APPLICATION FOR SUBMITTAL OF POST-APPROVAL DOCUMENT

South El Monte High School Modernization

CCD-21

Project Reference: South El Monte High School Modernization Date: 11/21/2023

1 BLDG L - ROOF
A1.L2 SCALE: 1/8" = 1'-0"

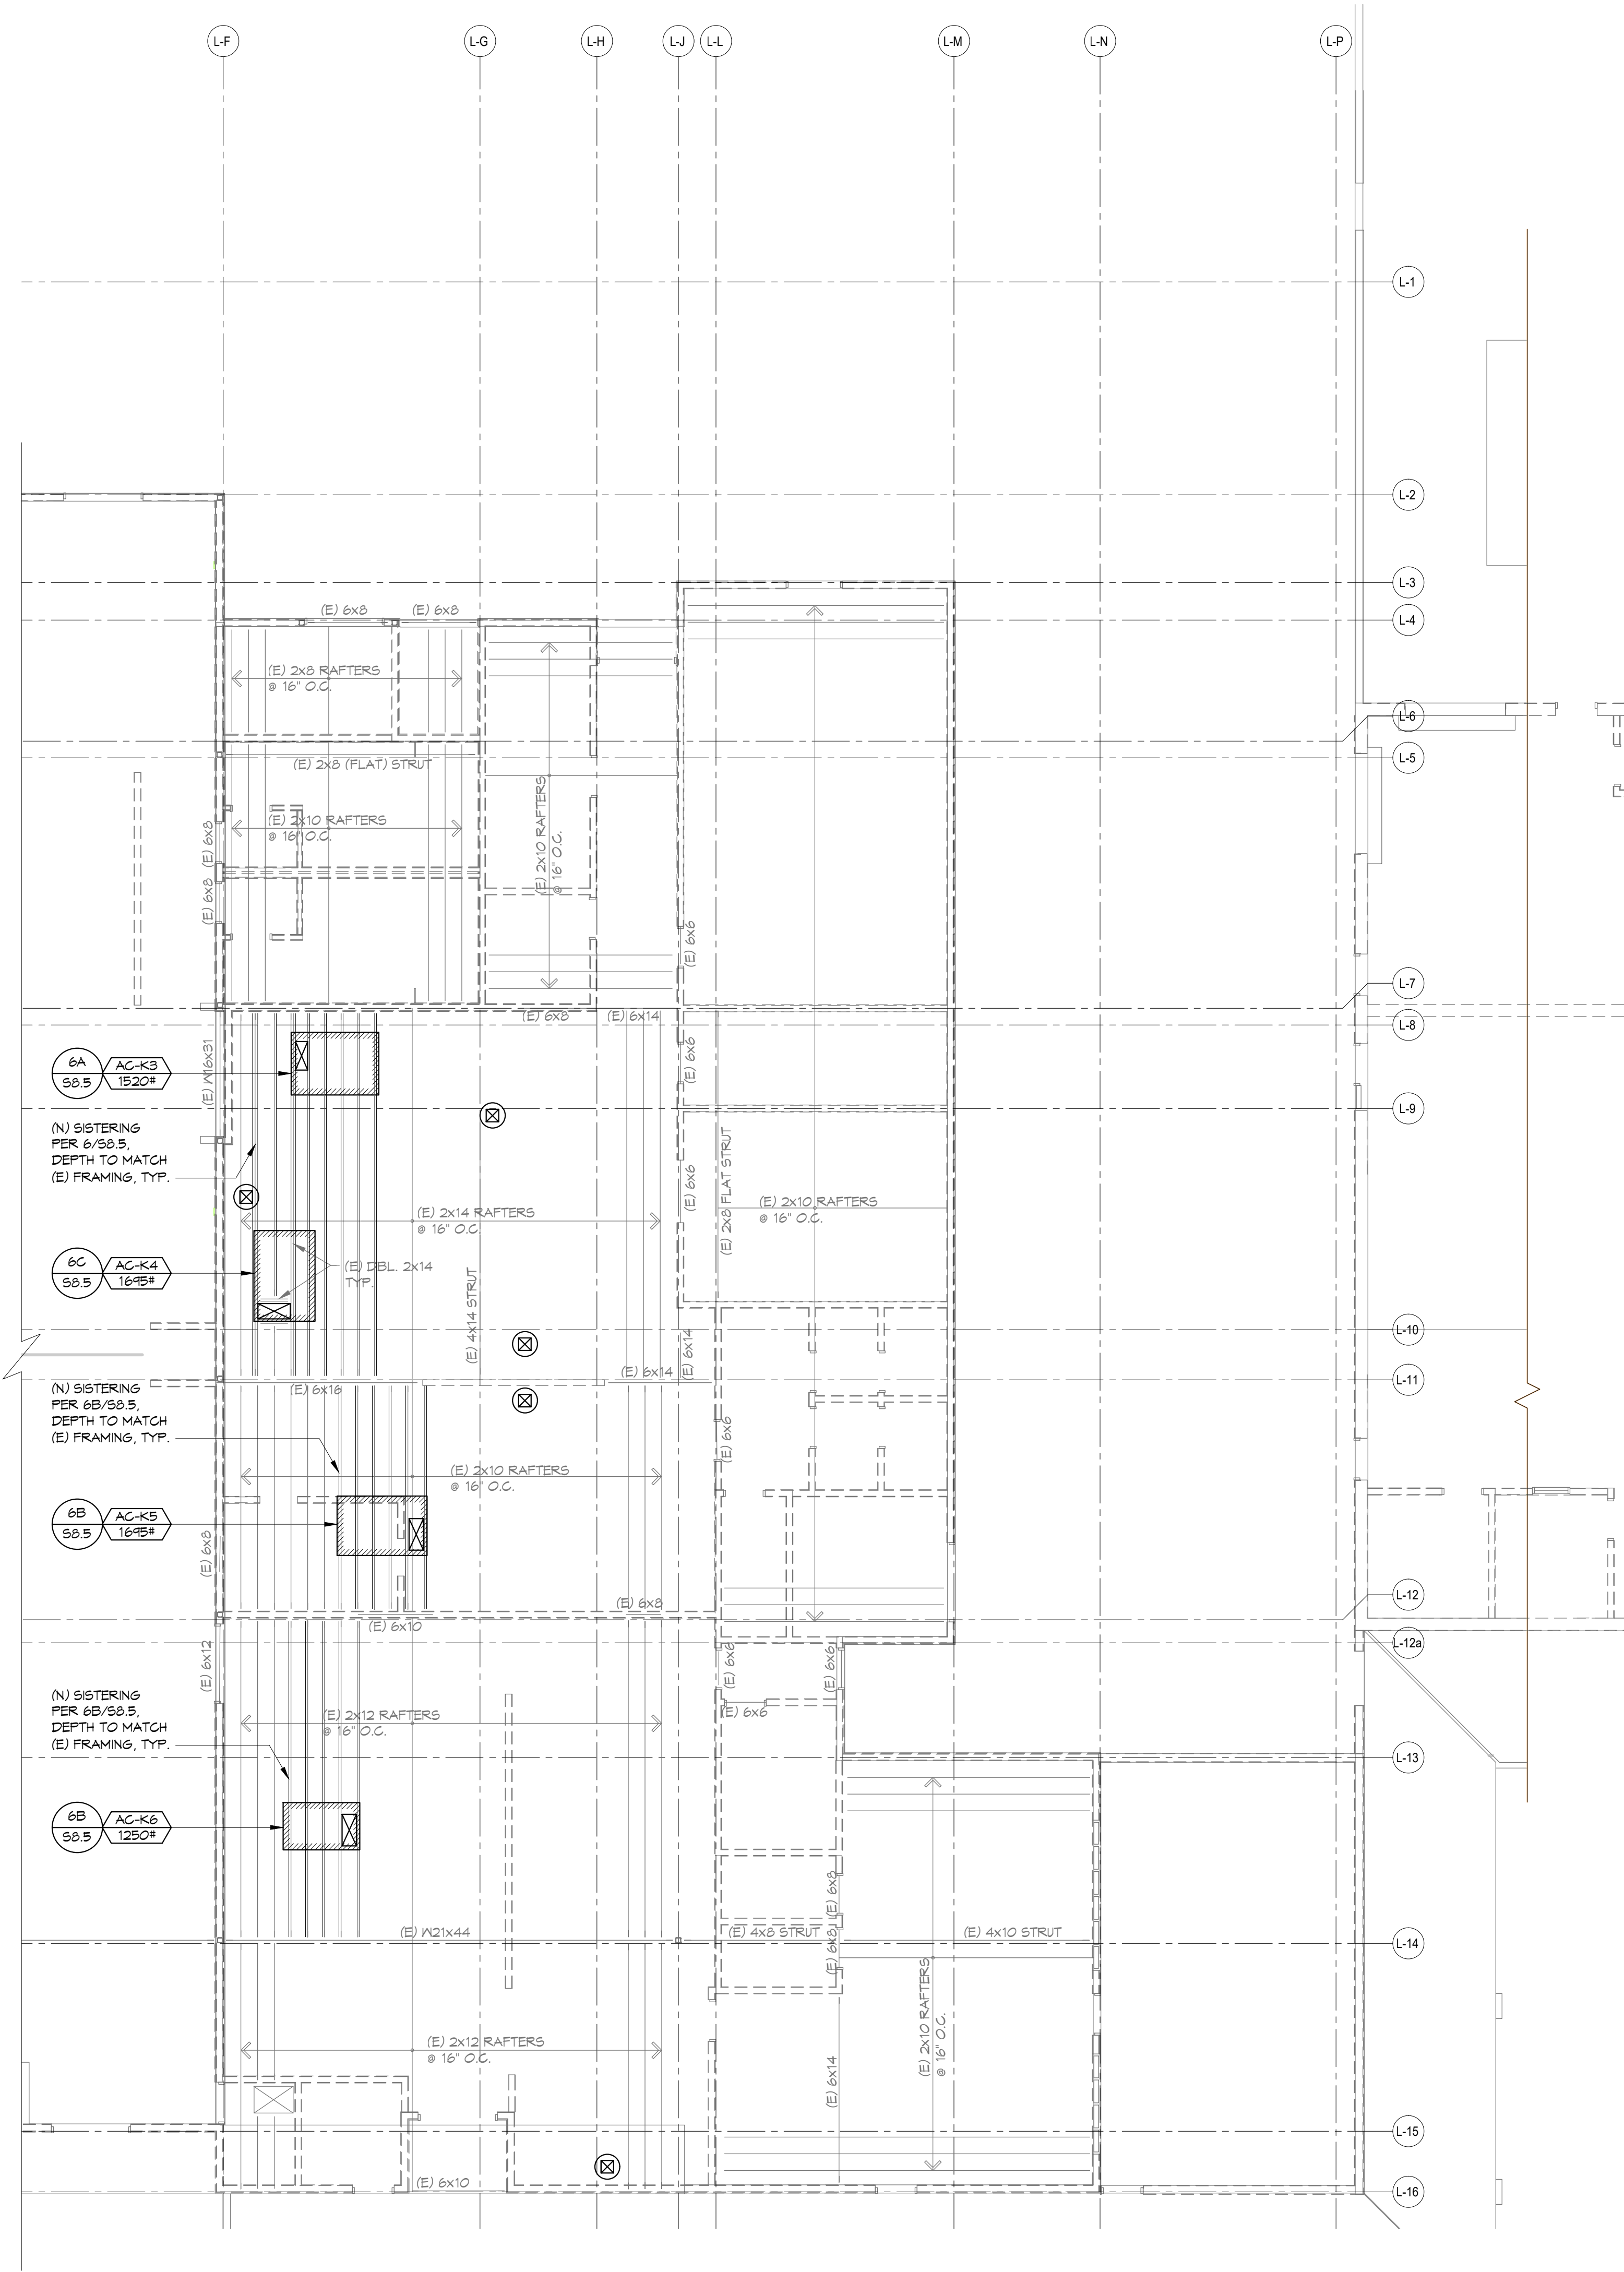
21.2. SHEET A1.L2 – ROOF PLAN – BLDG L CAFETERIA

21.2.1. New sheet provided to identify replacement of existing roof top HVAC units in between grid lines L-F and L-G.

1 PARTIAL ROOF FRAMING PLAN
BUILDING L

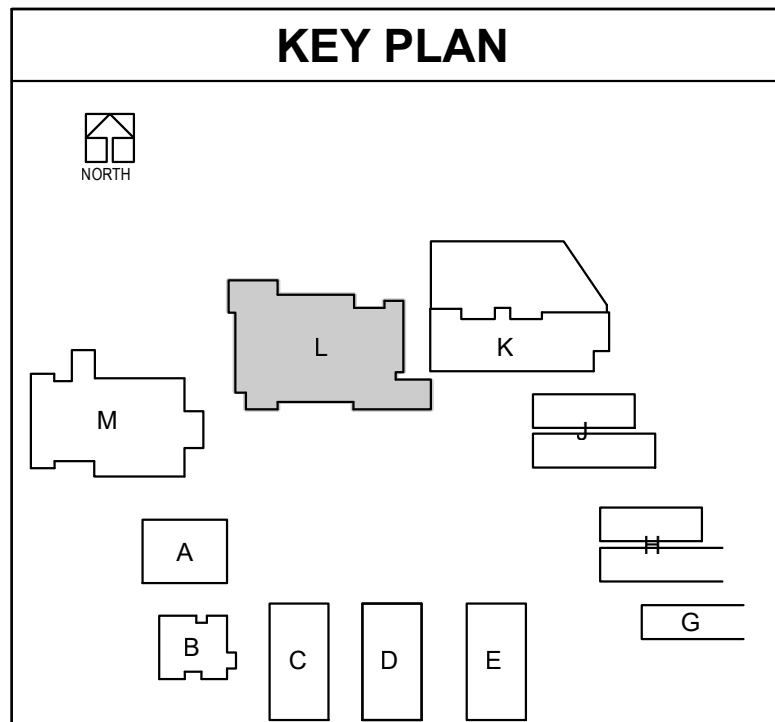
21.3. SHEET S1.L2 – PARTIAL ROOF FRAMING PLAN (BUILDING L)

21.3.1. New sheet provided to identify framing upgrades at the roof top HVAC replacement unit locations.

MECHANICAL DEMOLITION PLAN - BLDG L
SCALE: 1/8" = 1'-0"

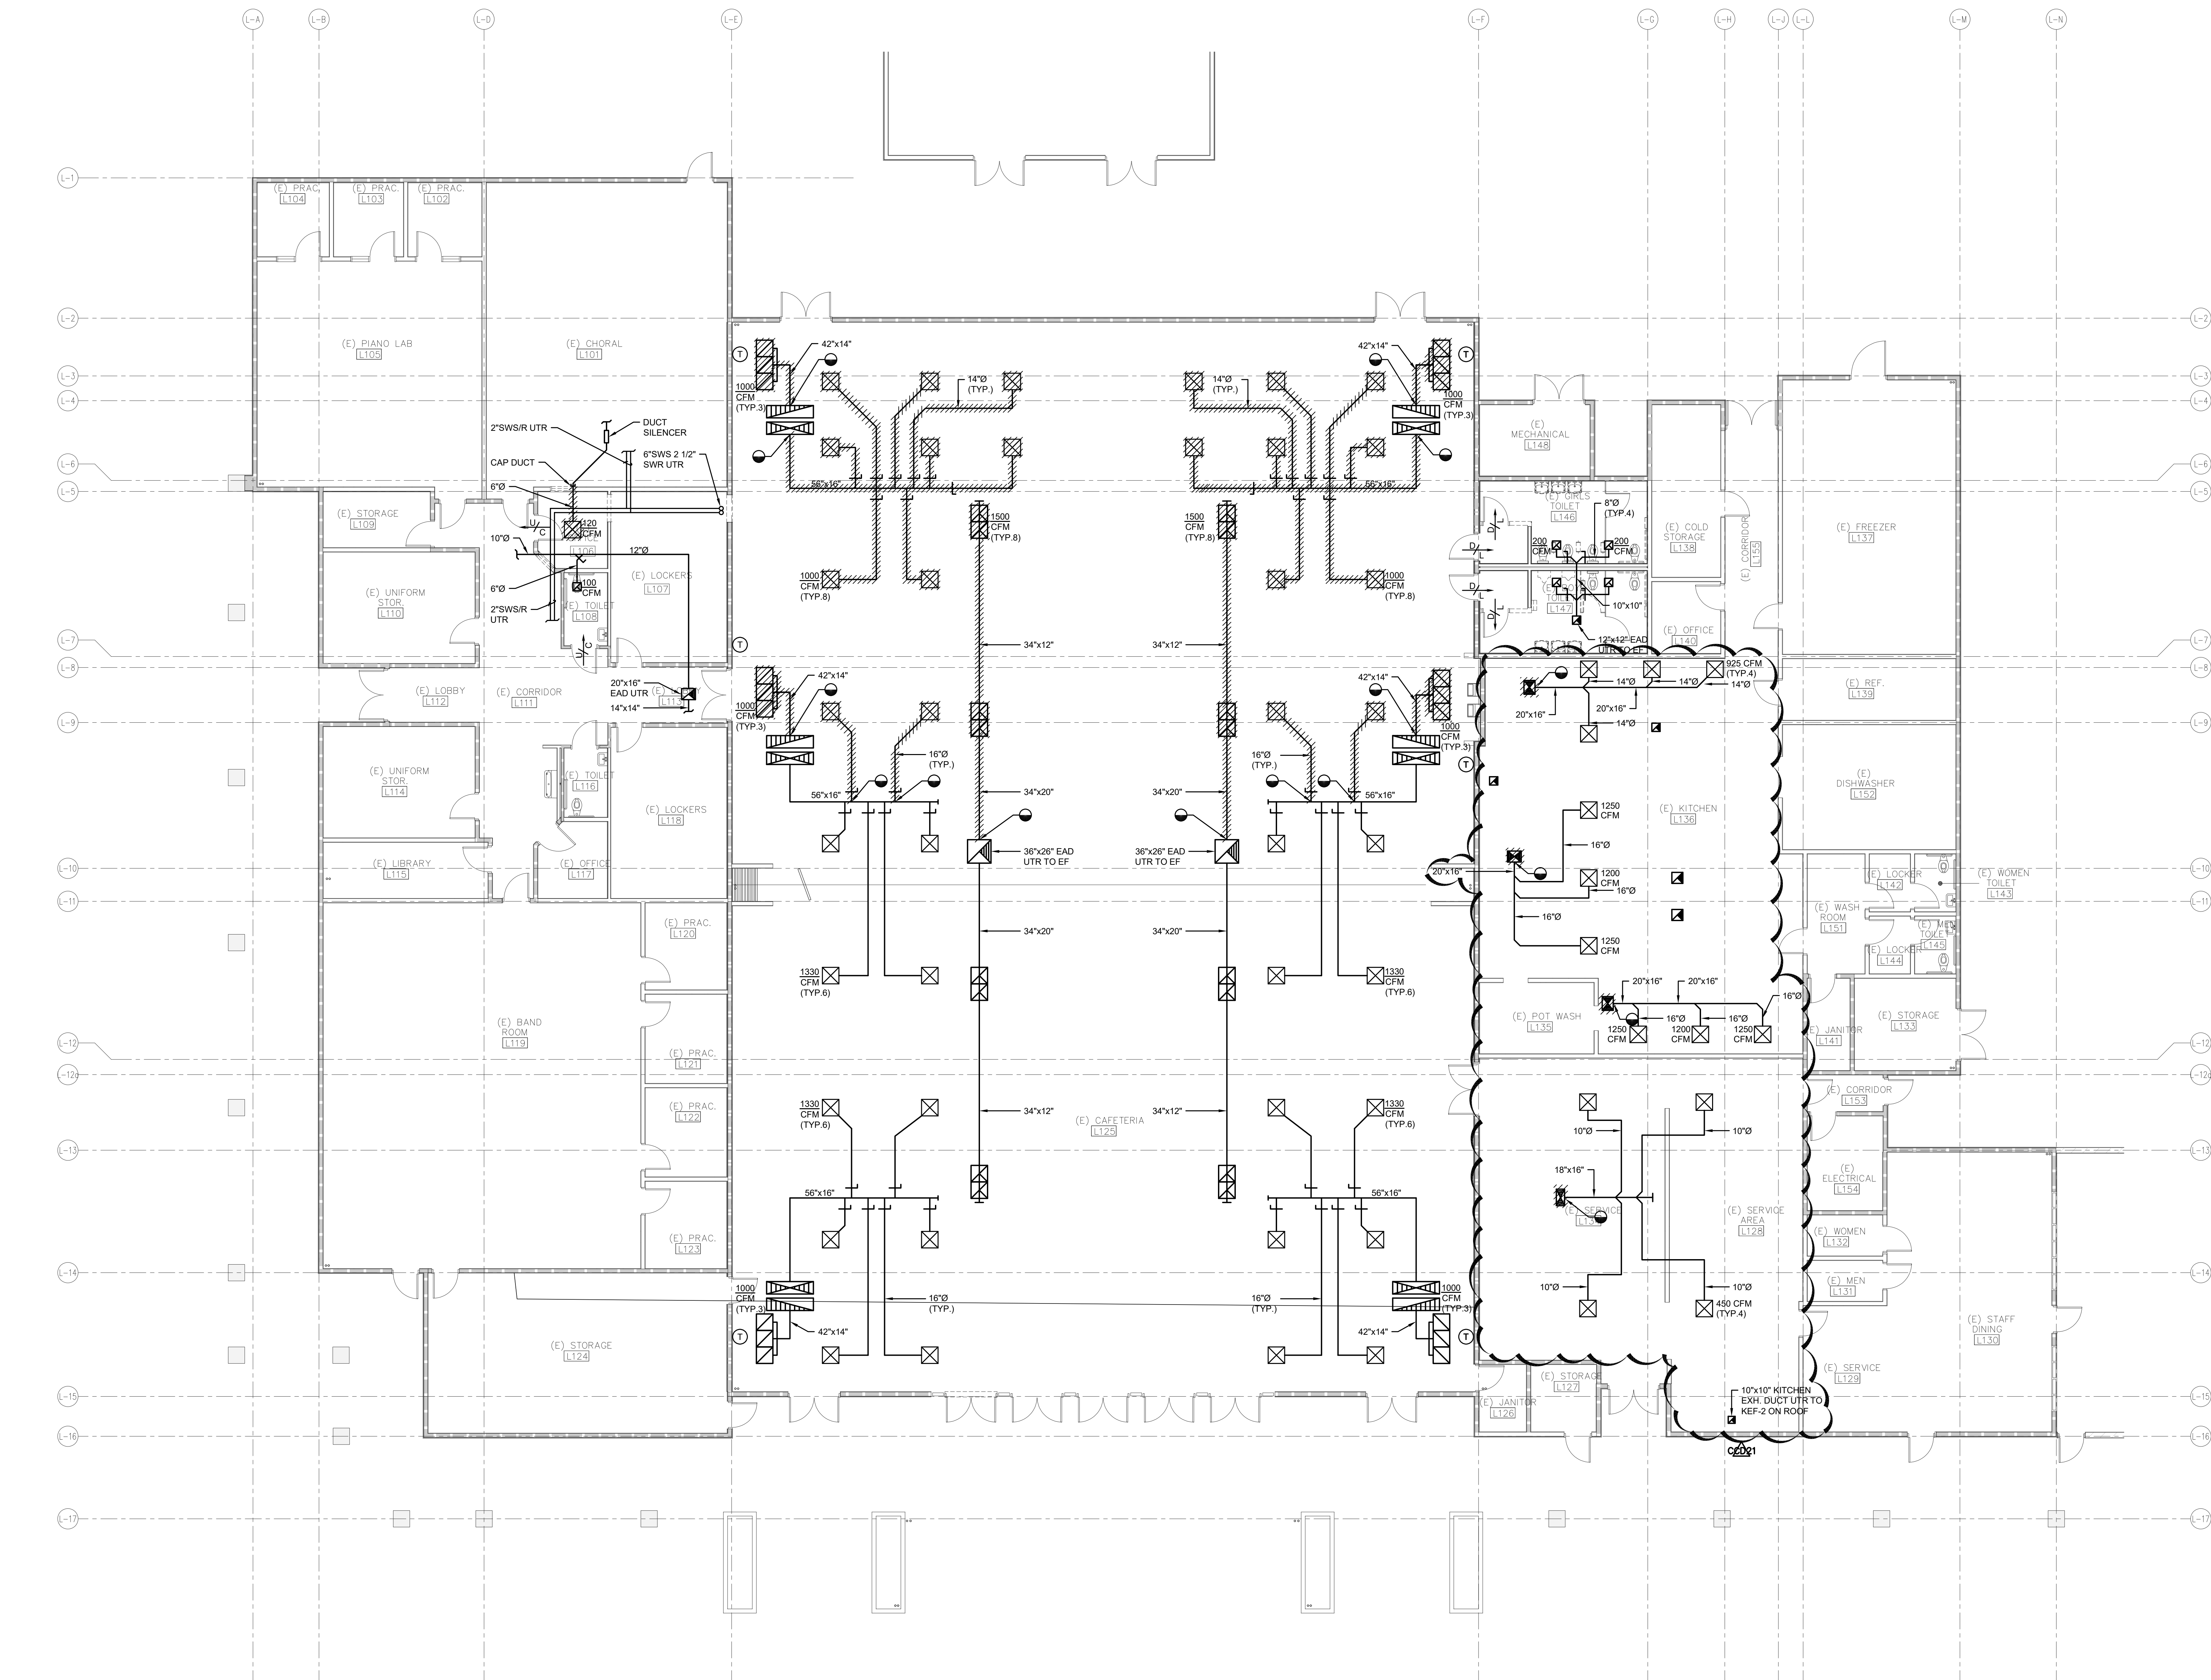
21.6. SHEET MD2.L1 – MECHANICAL DEMOLITION FLOOR PLAN – BLDG L

21.6.1. Noted ducting demolition at existing RTU locations within the existing food service area.
